Drainage Letter
Re: Sunset Village Filing 4 (1st Submittal)

Please add PCD File No. CDR-218 and provide a cover page for the report.

DETENTION BASIN STAGE-STORAGE TABLE BUILDER

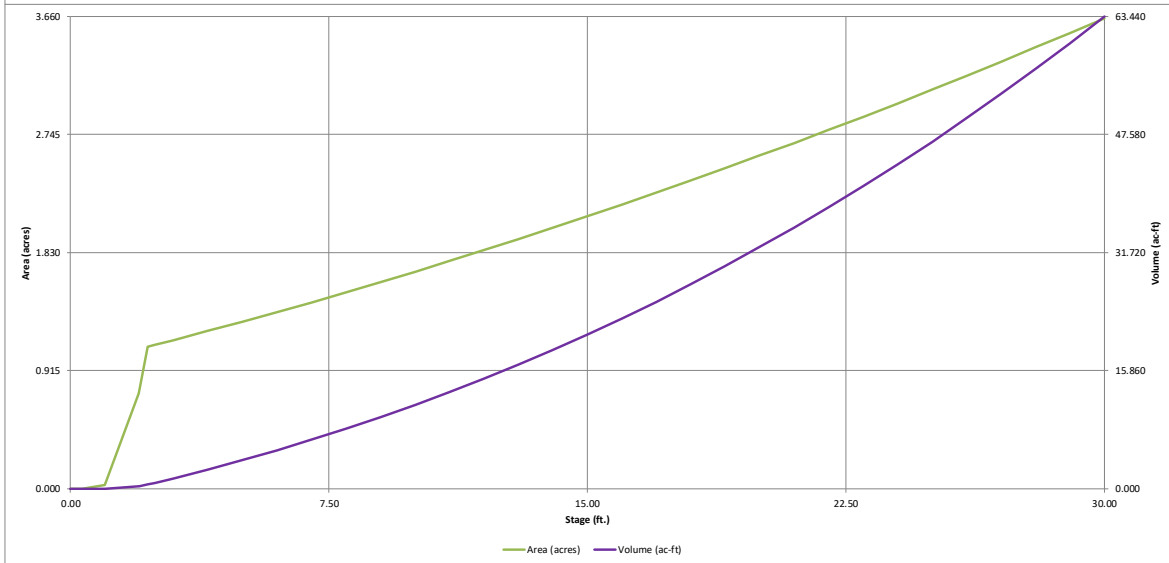
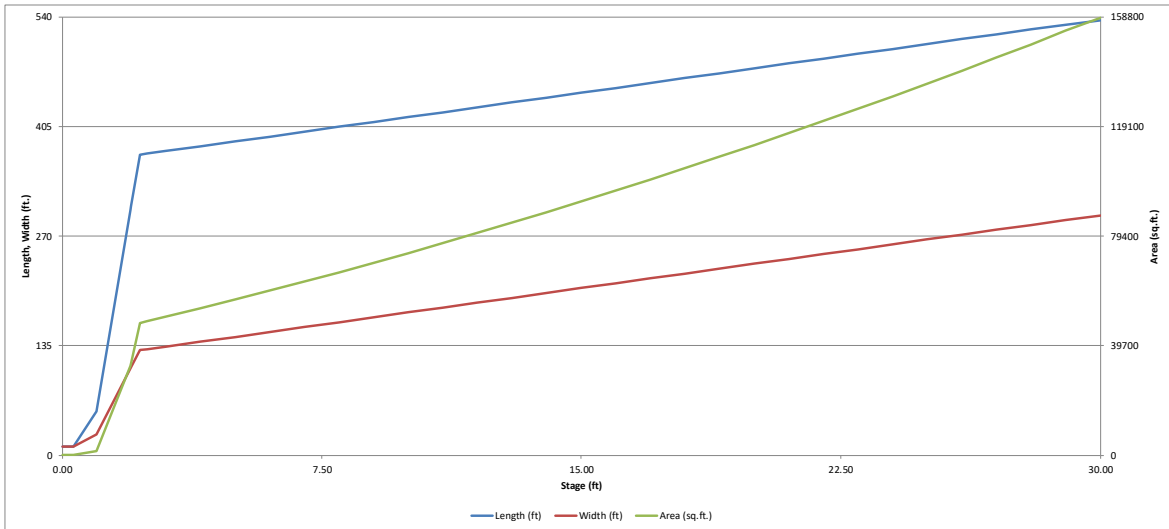
Input the existing (surveyed) pond stage-area information in the optional columns. If the existing pond does not have sufficient capacity then update the construction drawings to include a pond grading plan.

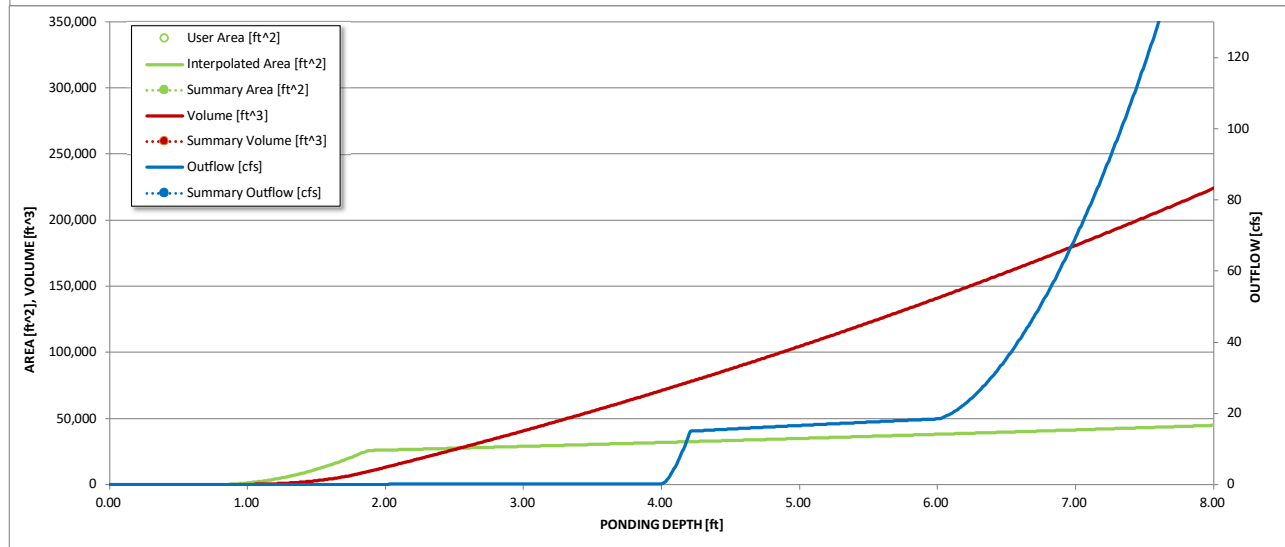
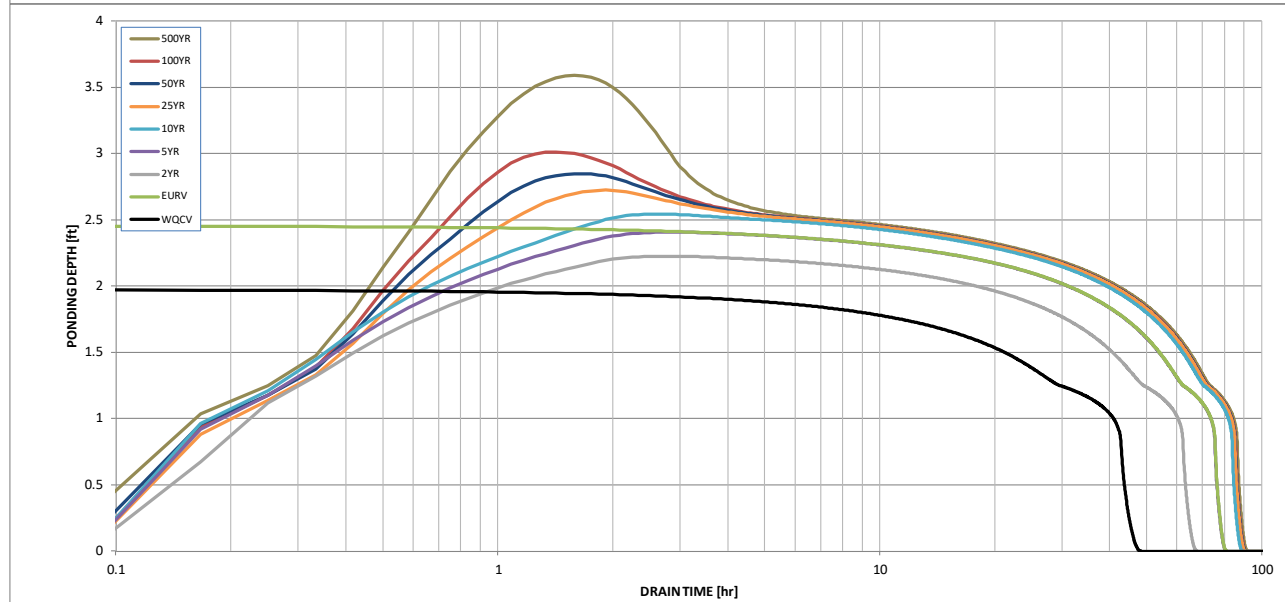
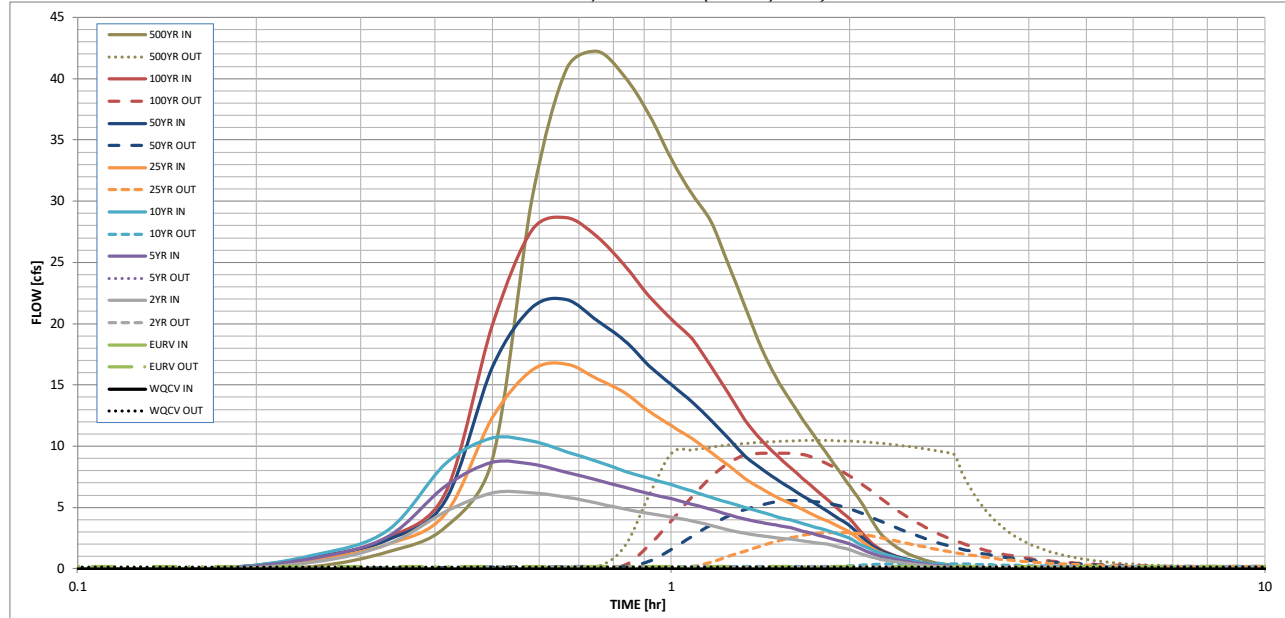
fix page layout. This is a part of the previous sheet.
